BID #24-26-D04
Sitework and Structural for Downtown Campus
Addendum One
Released 11/26/2024

ADDENDUM: Addendum One addresses a process to request to be added to a prime/sub list for this project, questions and clarifications, a revised bid form, and drawings for DLC and DTC.

**Rock Valley College
New Downtown Campus
Sitework and Structural
Bid #24-26-D04**

Architect's Project Number: 23-030

2 WF COLUMN BASE PLATES
 3/4" = 1'-0"

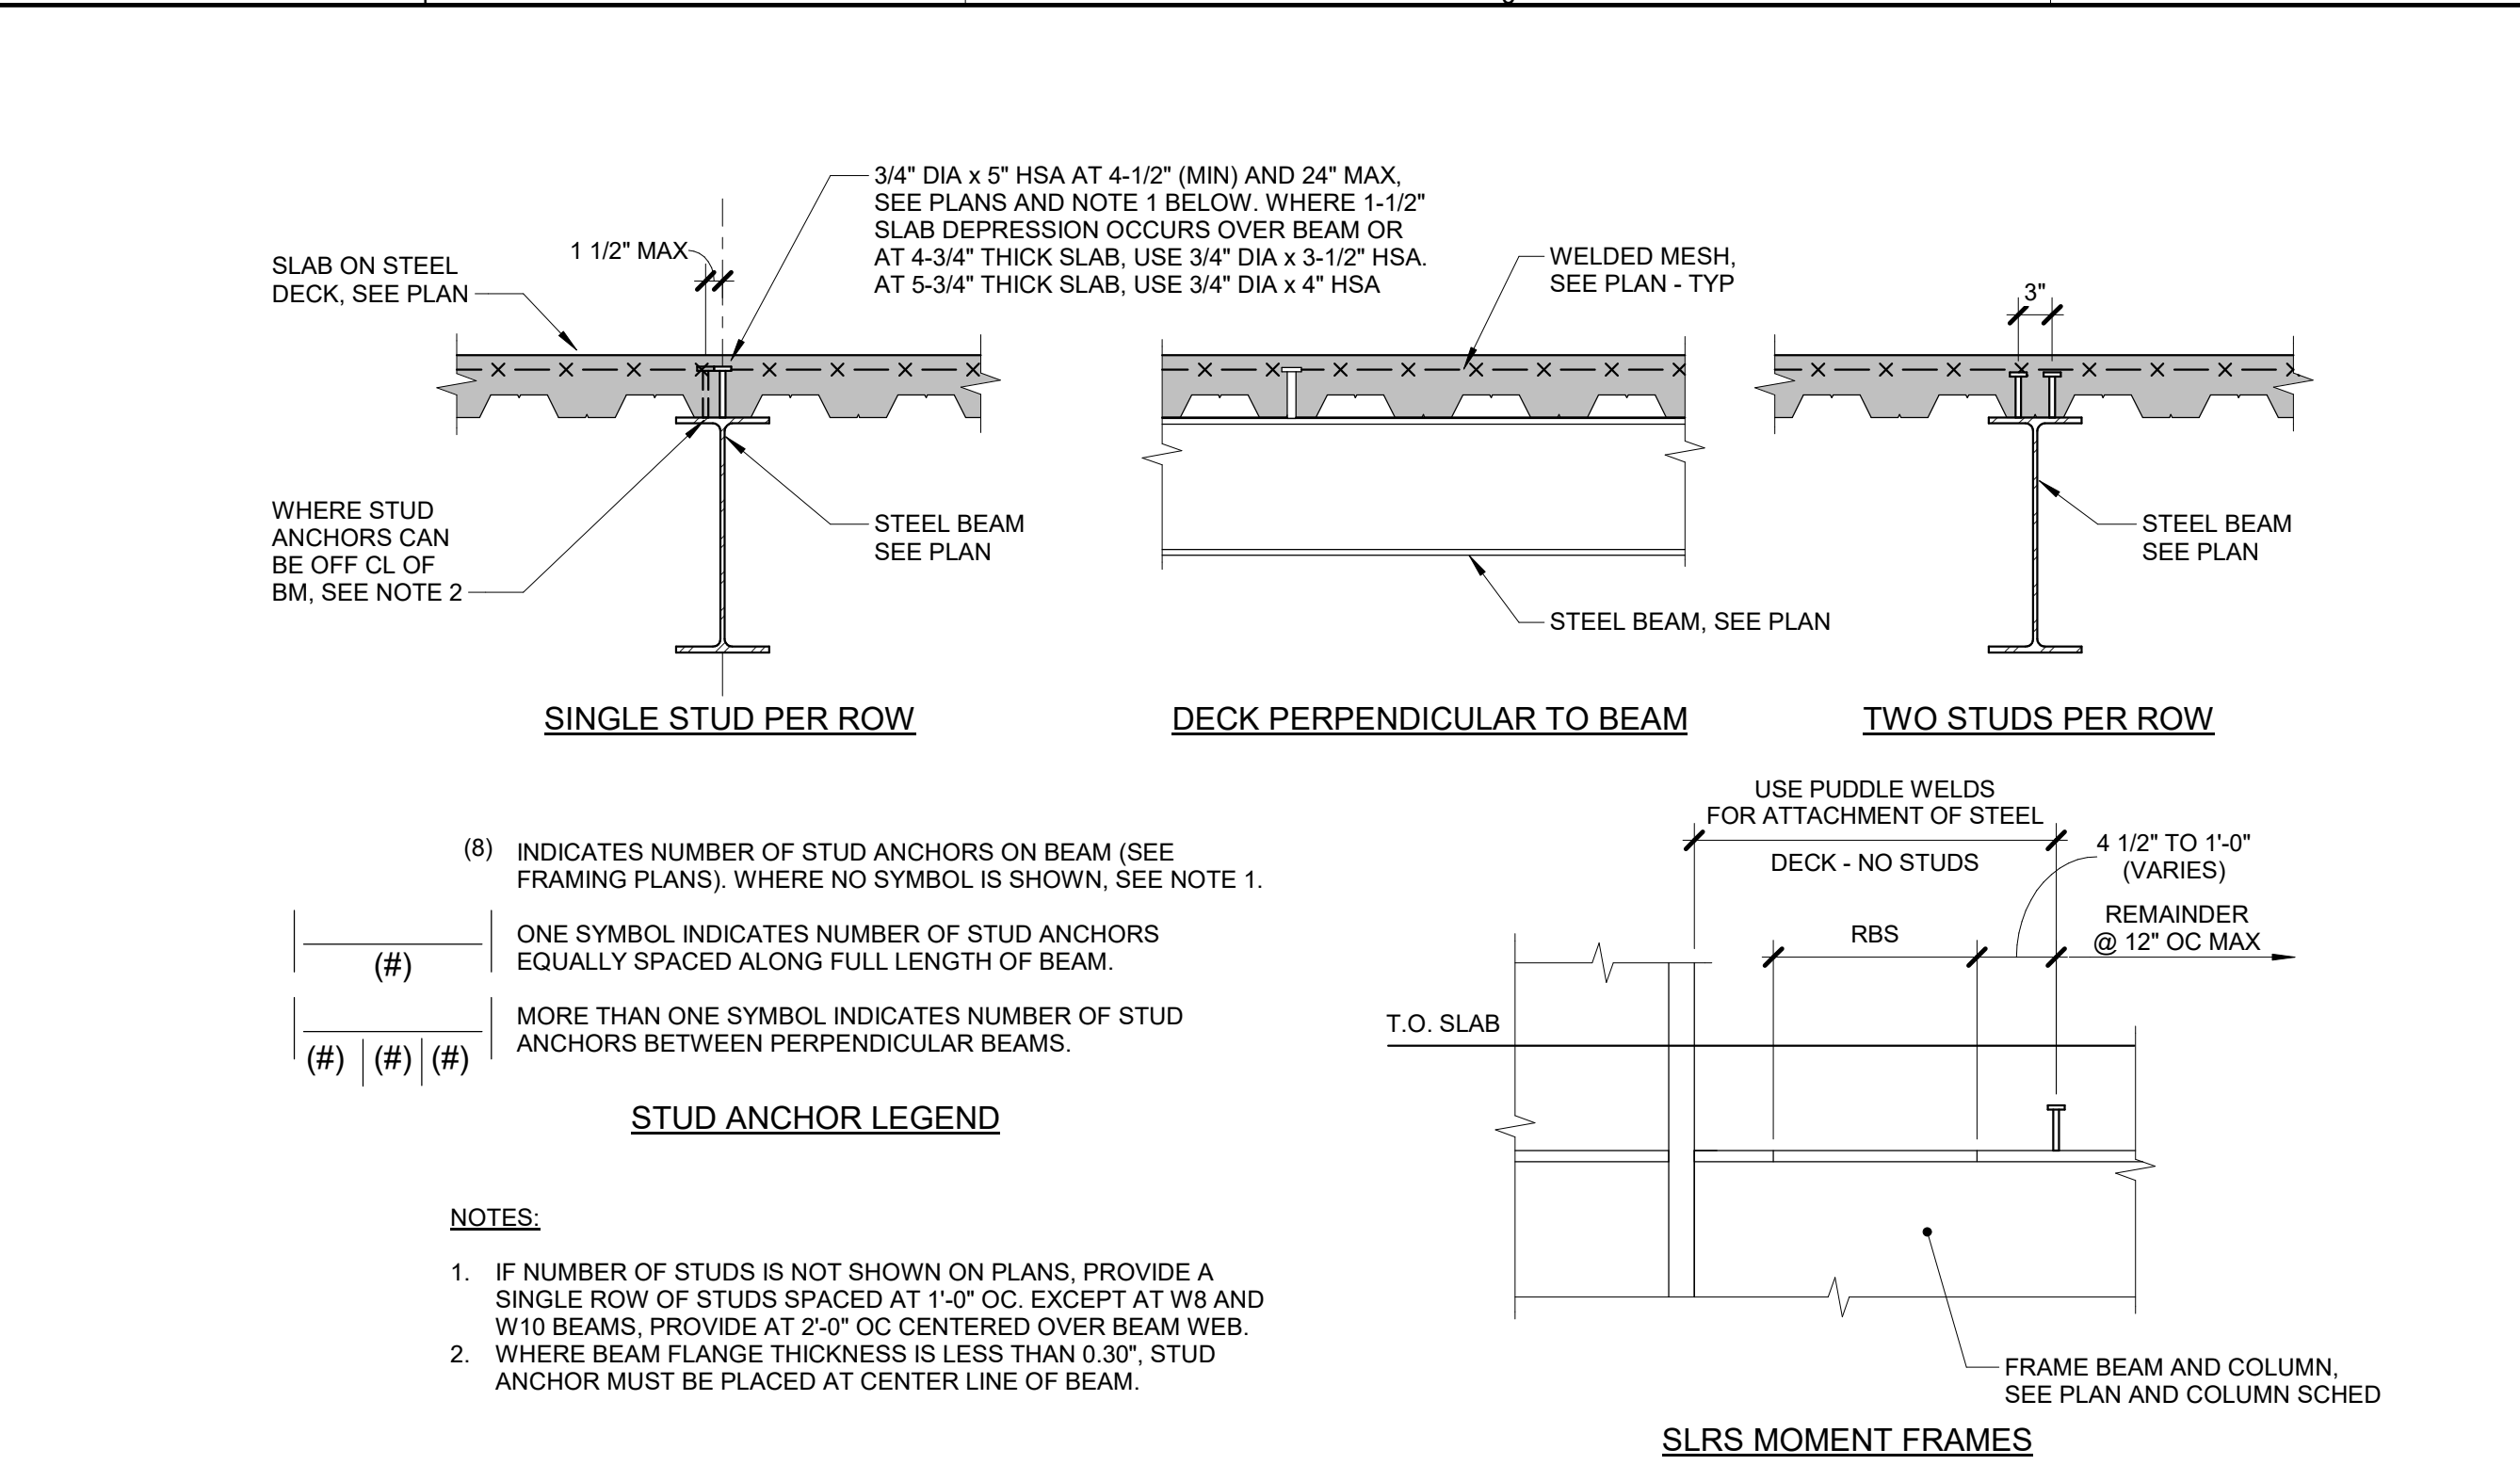
19. Sheet S2.01
 - A. Details 13 and 14 adjusted.
20. Sheet S3.00
 - A. Base plate schedules added to details 1 and 2.
21. Sheet S3.02
 - A. Base plate schedule added to detail 1.

SHEET NUMBER:
S3.12

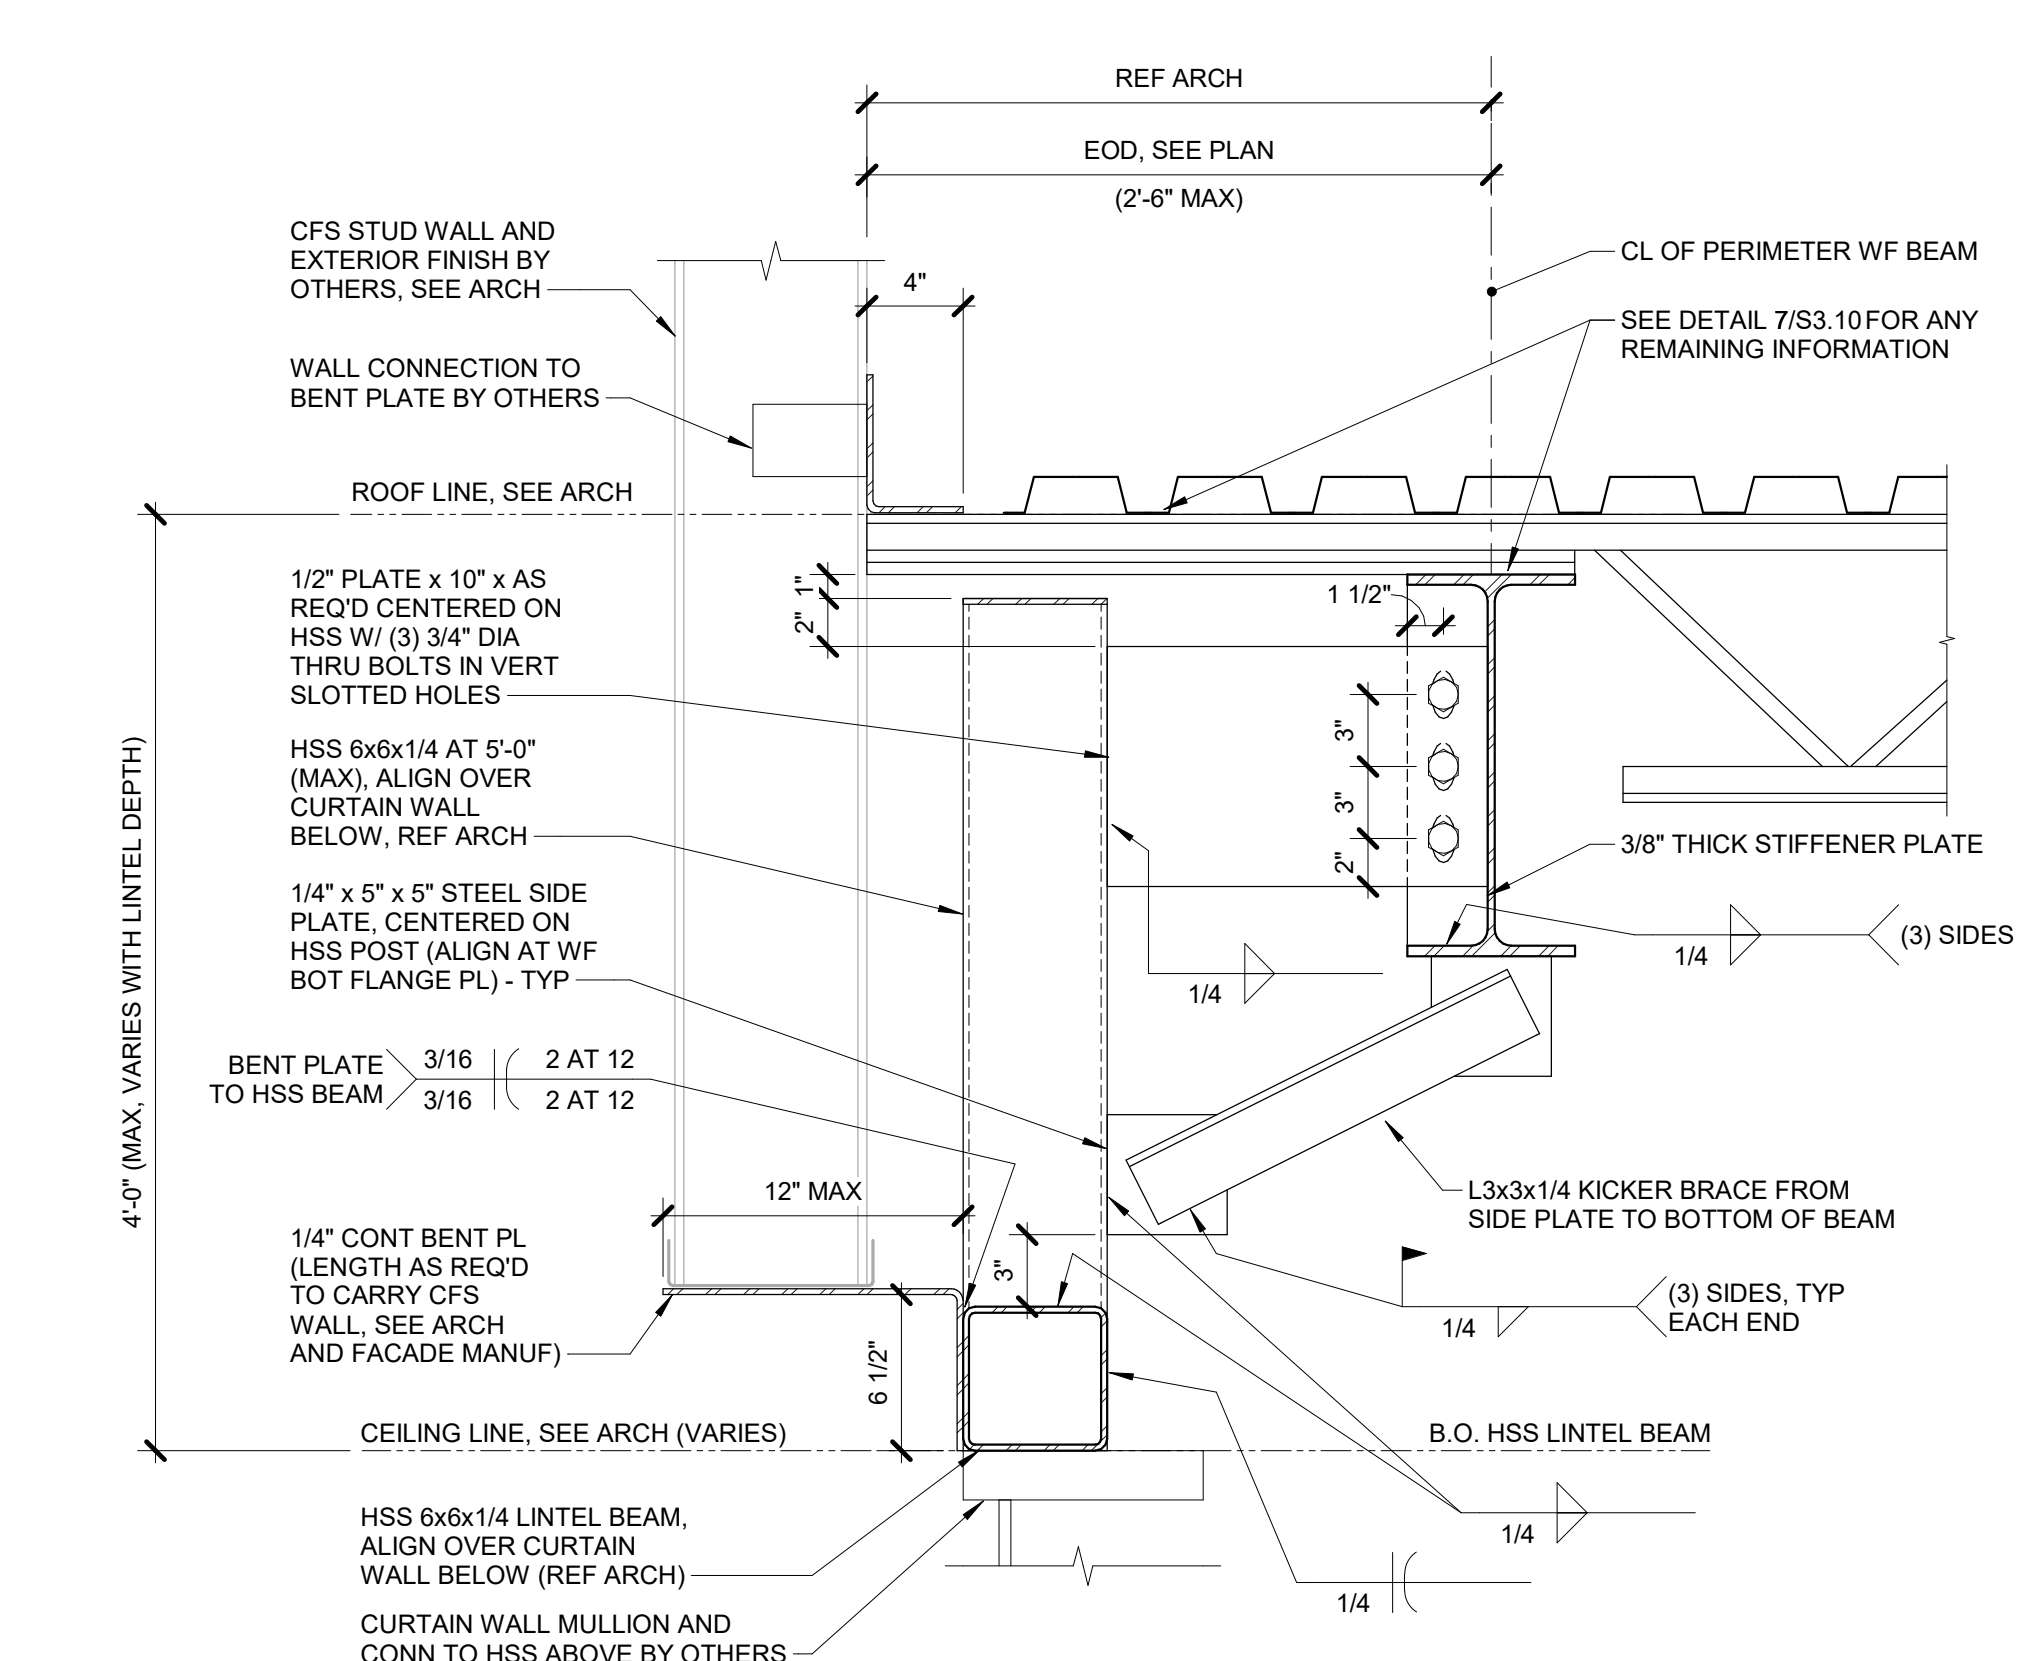
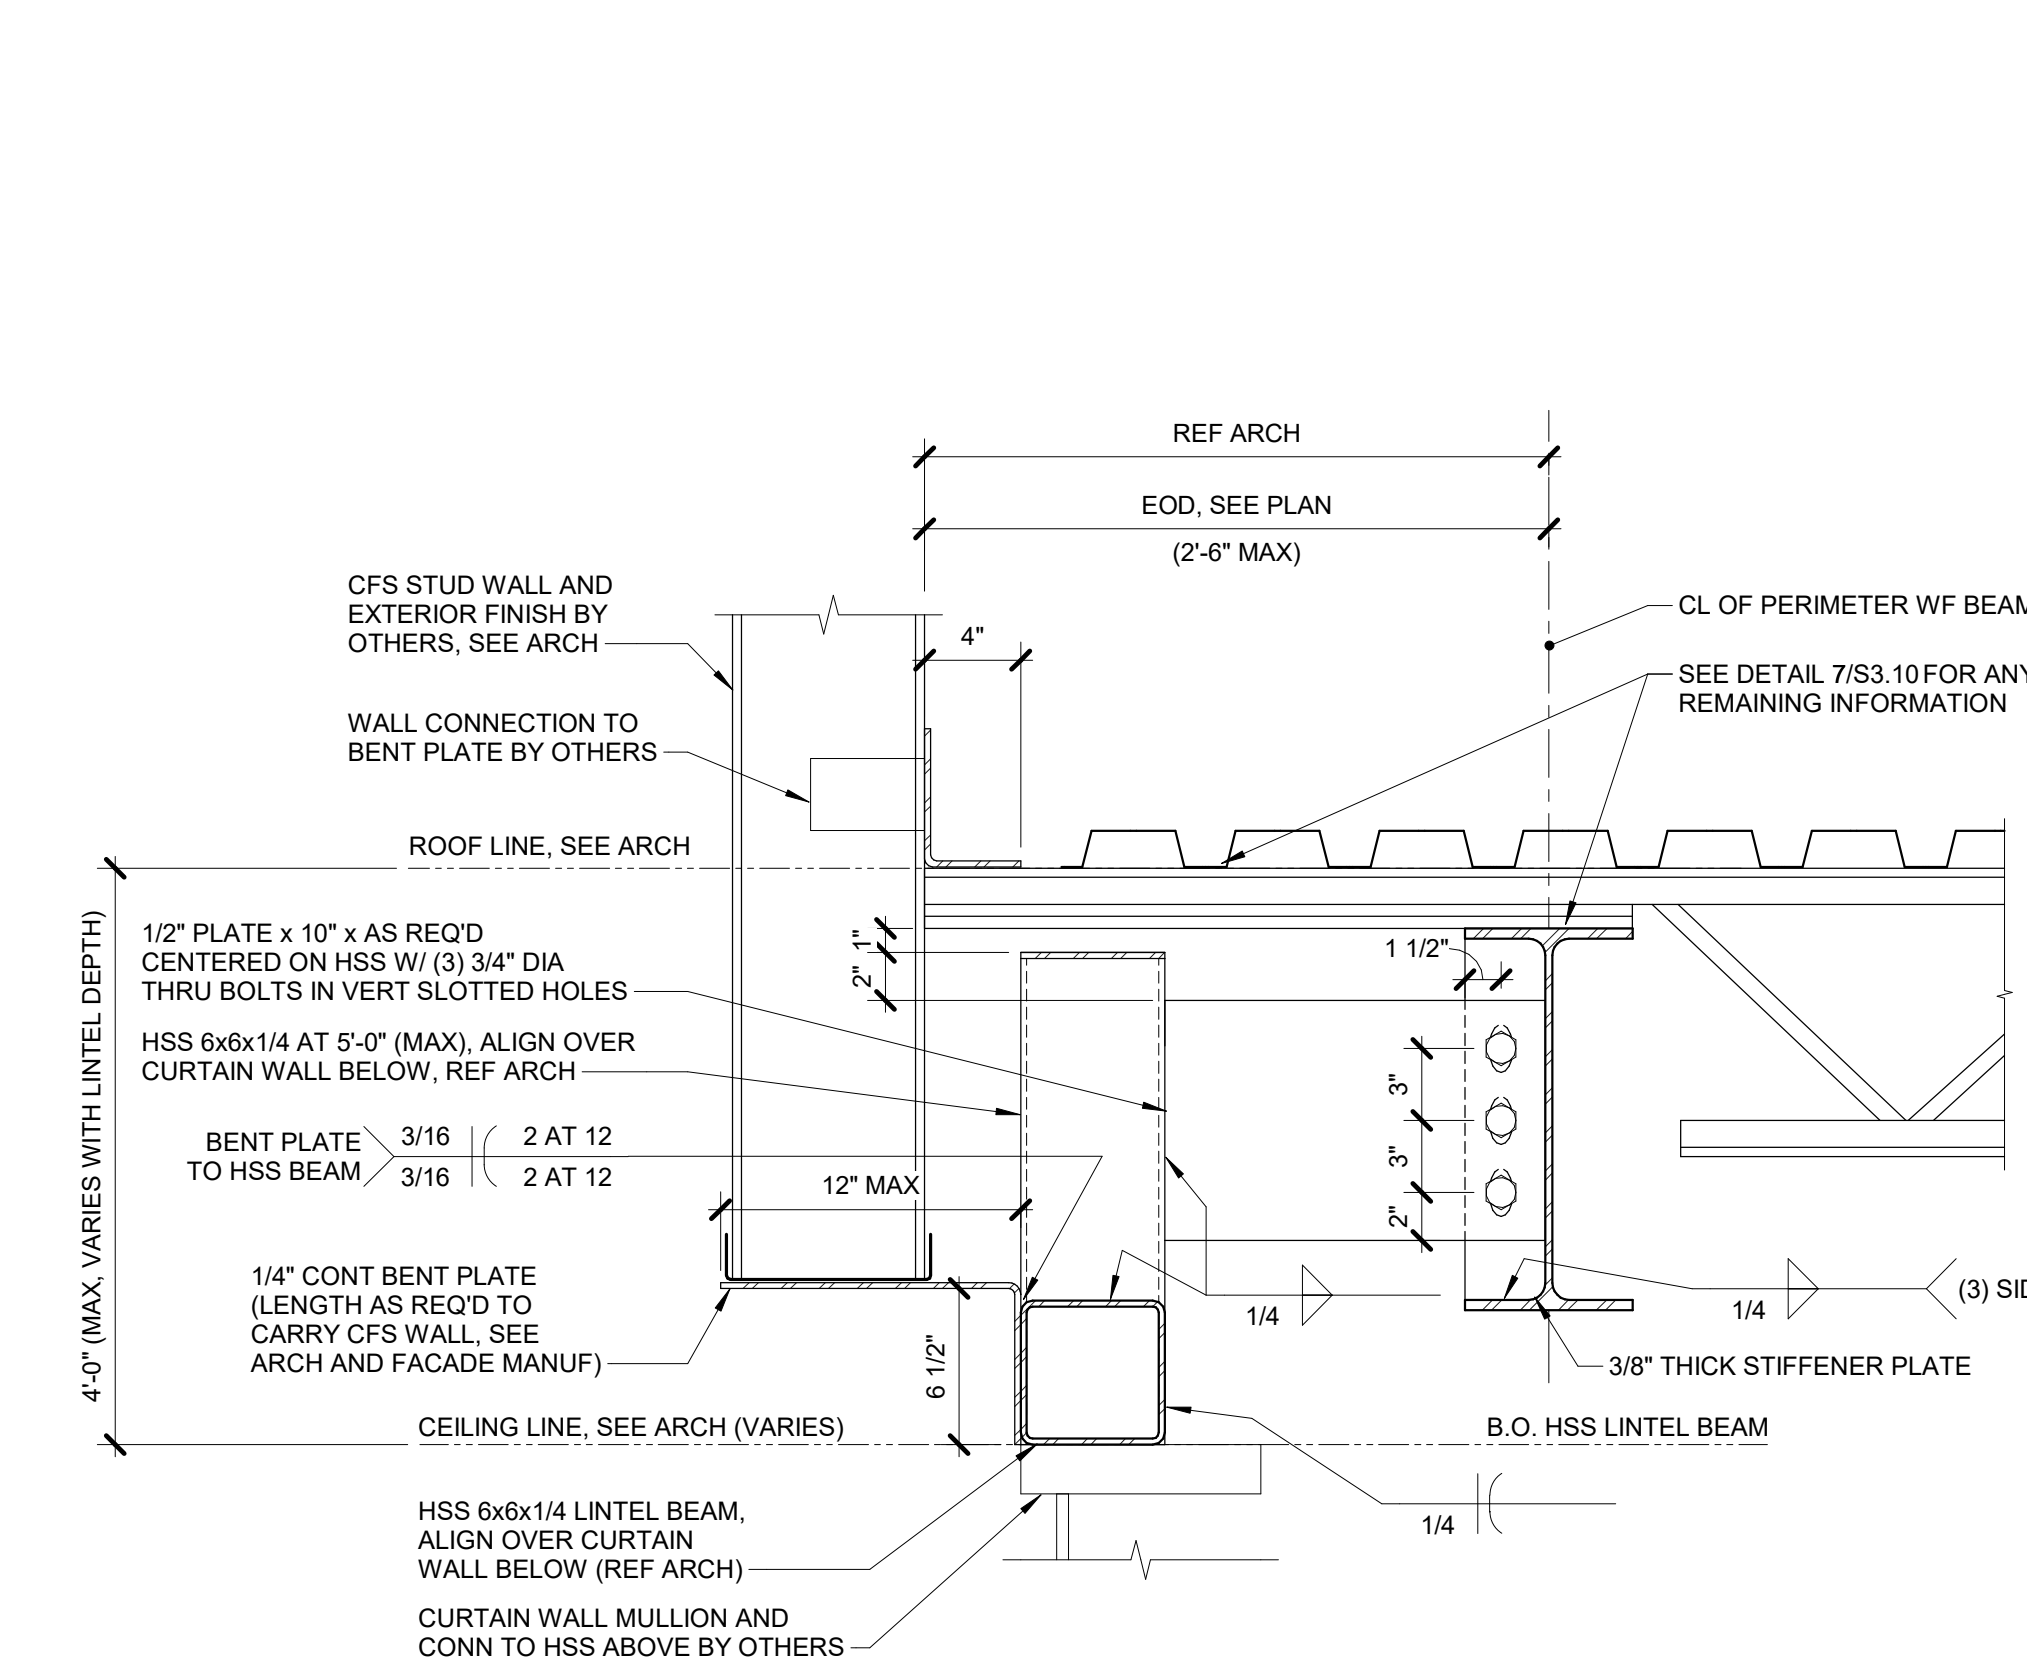
- B. Detail 6 updated to fit deeper brick dimensions below floor deck.
 - C. Details 10 and 11 added, see notes on plan sheets.
22. Sheet S3.12
 - A. Detail sheet added
